# ***Farnborough Airport***

**Additional Airspace Consultation  
(Limited in scope and area)**

Figure 3 Typical flow, spread and altitude for this proposal. This is the same map area as Figure 1, Figure 2.

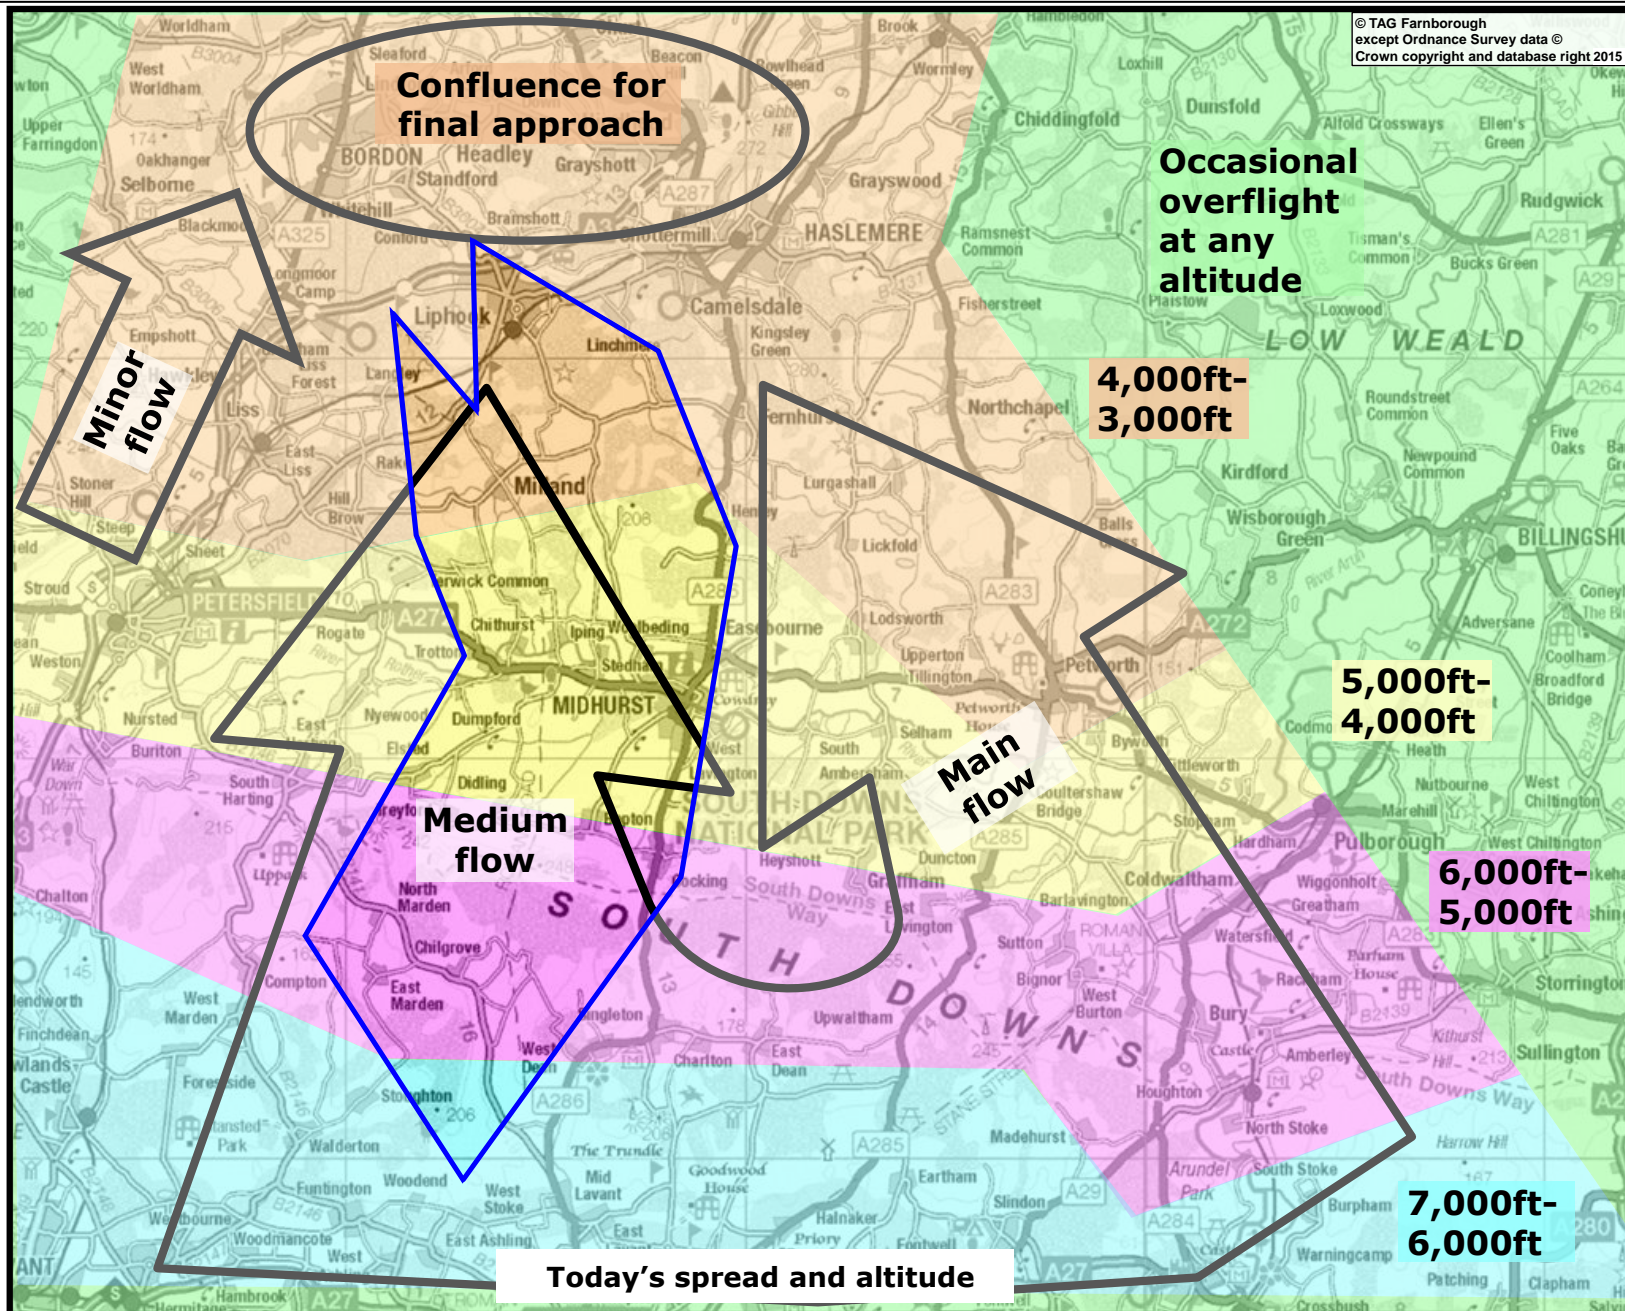
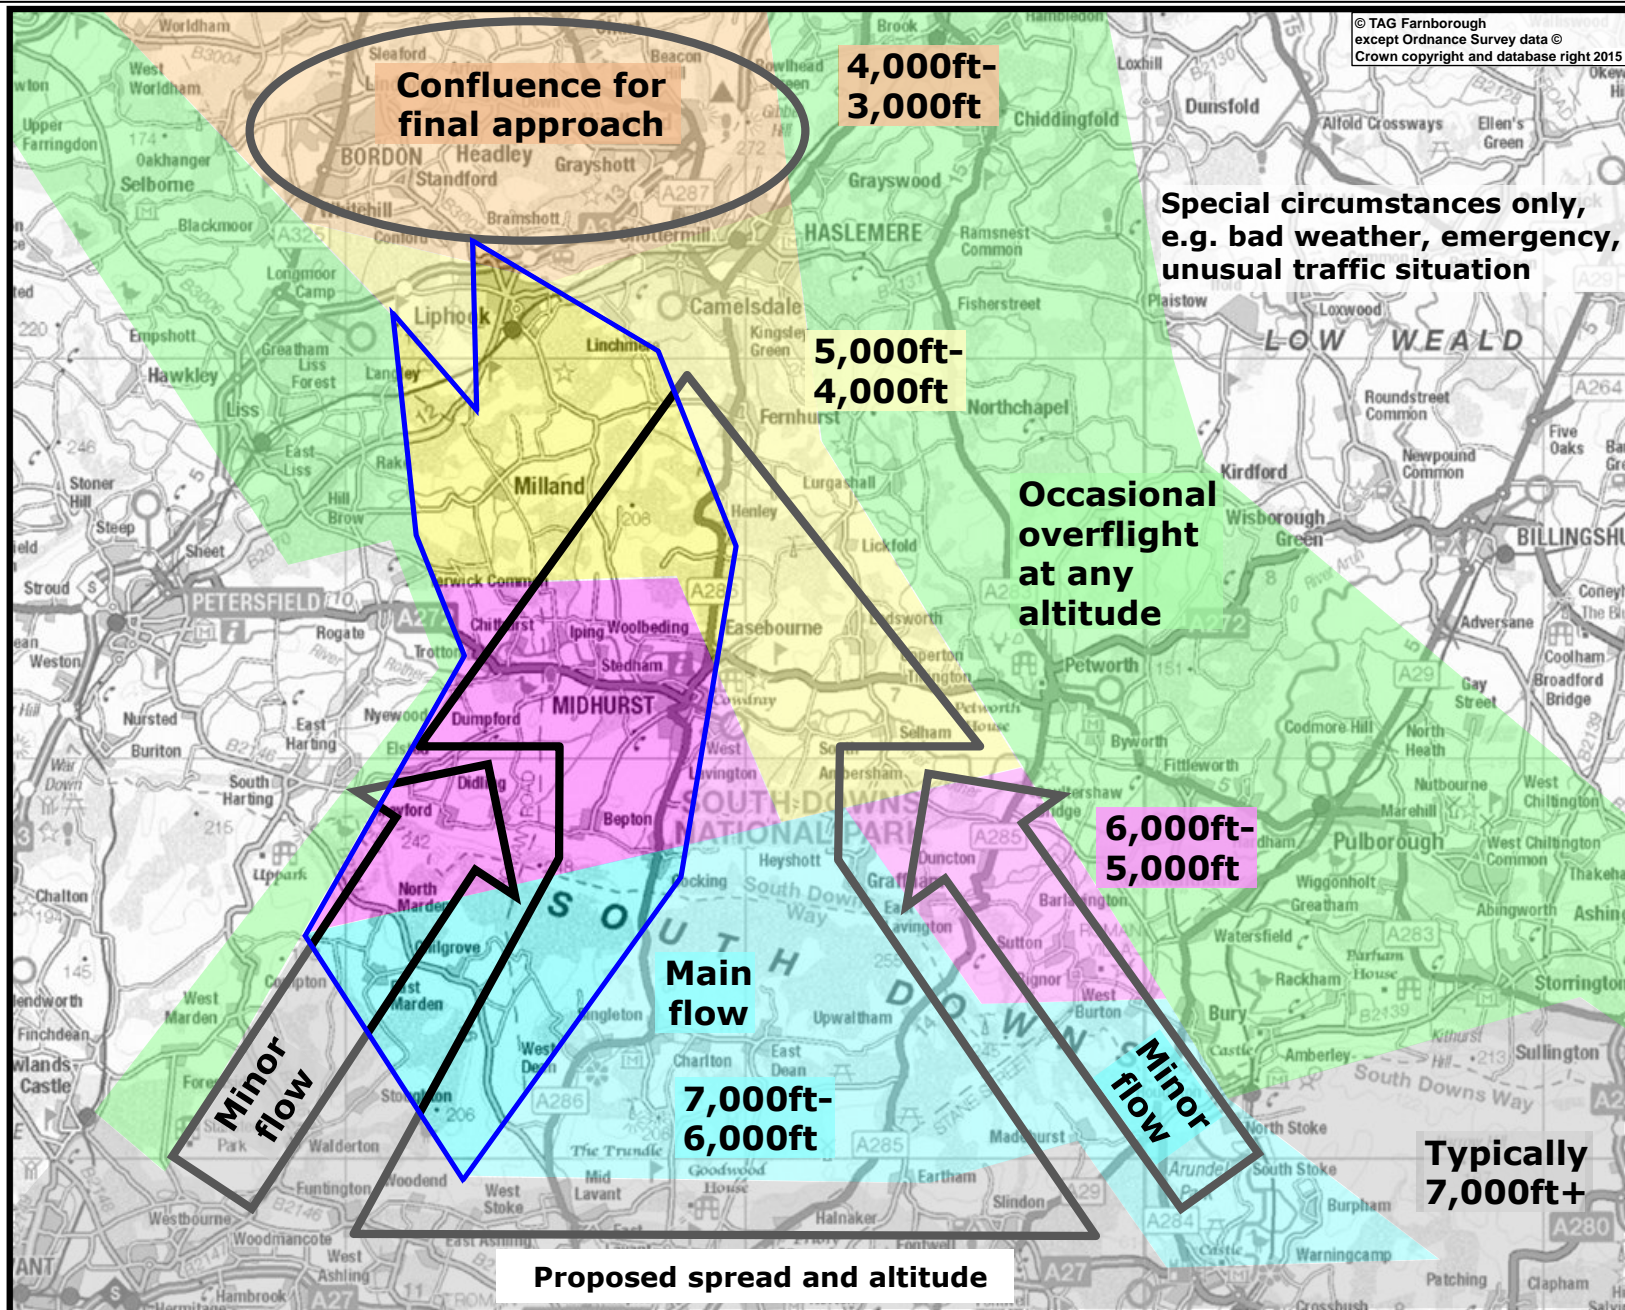
- 3.6. Today the variable paths flown by individual aircraft, when added together, comprise a very wide swathe. This swathe is made of three generic air traffic flows<sup>3</sup>. Figure 2 overleaf shows the overall spread of today's flights, and the colours show the typical altitudes of those flights.
- 3.7. The flows converge as they descend northwards, until they merge into one main flow which takes them towards the runway. This occurs in an area to the south of TAG Farnborough Airport, marked on Figure 2 as 'confluence for final approach'.

- 3.8. Under this modified proposal the main convergence would be more likely to happen further south, forming one main flow with two minor flows<sup>3</sup>. This would be positioned further west than today, as shown in Figure 3 on page 9.
- 3.9. Generally, the main flow and minor flows would still be spread over a wide area as illustrated by the arrows in Figure 3. The overall flow width would be narrower than today.
- 3.10. Figure 3 shows the spread expected as a result of this proposal, and the colours show the expected altitudes. In the blue consultation area flights would typically be at similar altitudes to today.
- 3.11. Overflight of the South Downs National Park would change as per the paragraphs above. You may wish to consider impacts on the South Downs National Park in your response.

**Figure 7 Comparison of Option 25 (top), Option 34 (middle), Option 36 (above)**

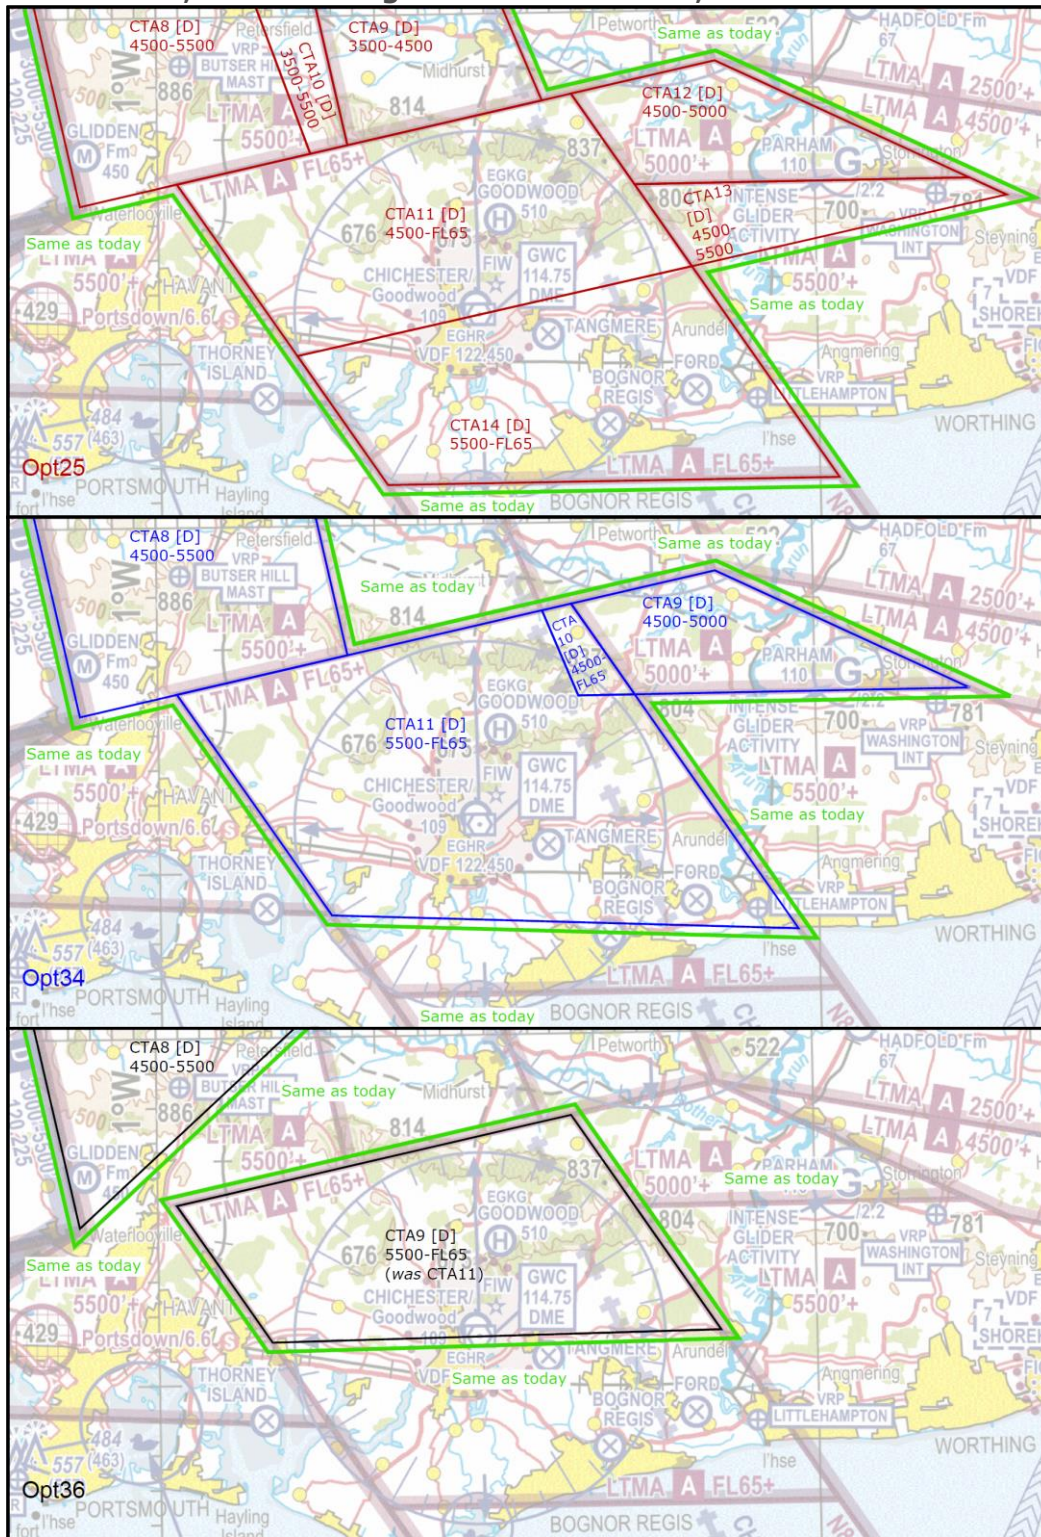
- 4.12. The evolution from Option 25 can be seen, as volumes were reshaped. In Option 36's case, the airspace outside the CTA is entirely unchanged from today, hence the green outline.
- 4.13. Option 34's CTA9 and CTA10 have been deleted. This deletion further mitigates the impact on Southdown Gliding Club at Parham. Option 34's CTA11 has been significantly reduced in size by truncating it at GWC, and renumbered CTA9 for Option 36. This further mitigates the impact on users of Goodwood aerodrome, especially those wishing to climb out to operate to the south at higher altitudes. The east-west line through GWC simplifies navigation: south of the line the CAS base is LTMA FL65, north of the line it is CTA9 at 5,500ft.
- 4.14. Option 36's CTA9 remains Class D, accessible via clearance to all radio-equipped aircraft, including unpowered.

Figure 9 Comparison of Option 25 (top) with Option 34 (middle) and Option 36 (above)

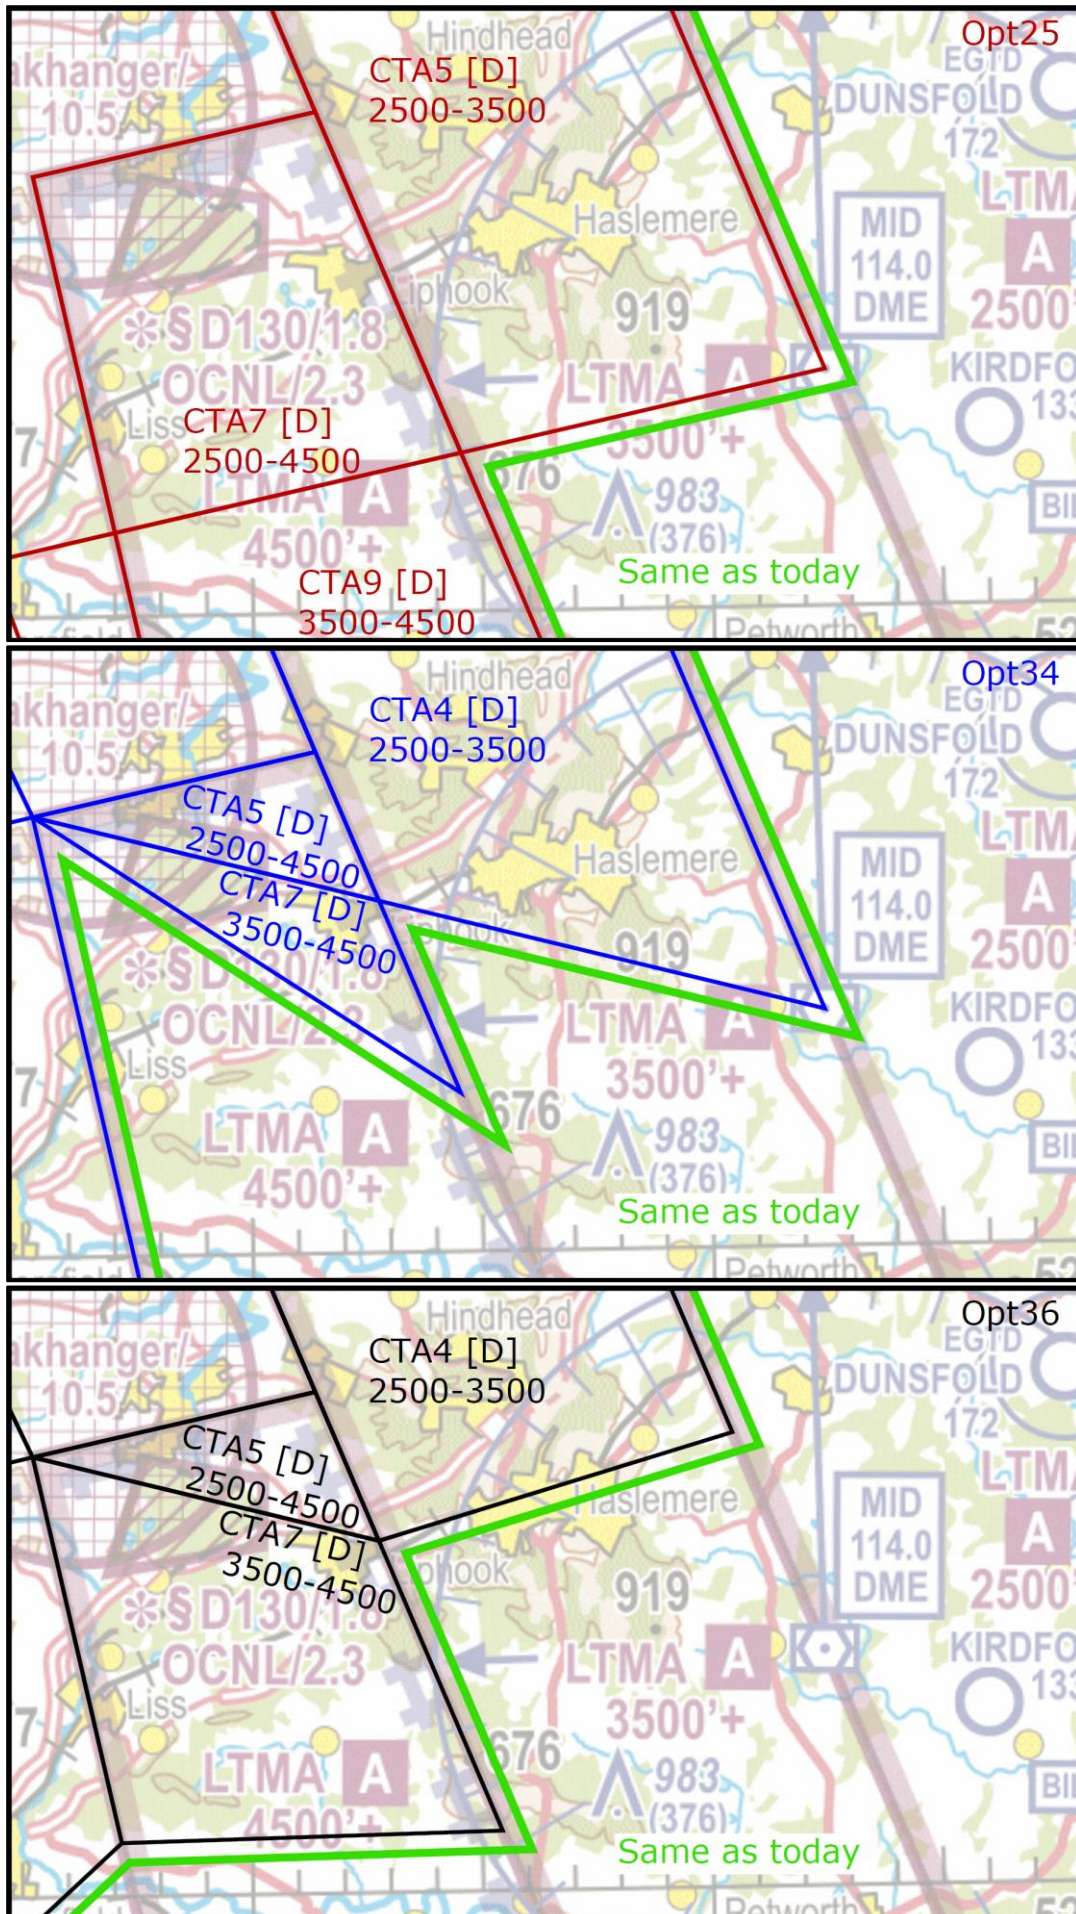
- 4.19. The evolution from Option 25 can be seen, as volumes were reshaped. The green outlines highlight where there is no change from today's CAS.
- 4.20. Option 25's CTA5 was reduced into Option 34's CTA4, which has now been truncated into Option 36's CTA4.  
This mitigates the impact on airspace users in the vicinity of MID VOR. Navigation becomes simpler because the boundary crosses Haslemere, in line with Dunsfold and Liphook.

- 4.22. Option 34's CTA7 has been widened into Option 36's CTA7. This wider volume is required to protect the RNAV1 STAR route in its new position further west than in Option 34, and also to provide vectoring space for Runway 06 arrivals. For a full overview, including the STAR position, see Section 7 on pages 18 and 19.

- 4.23. CTA7 remains Class D, accessible with a clearance to all radio-equipped aircraft, including unpowered.
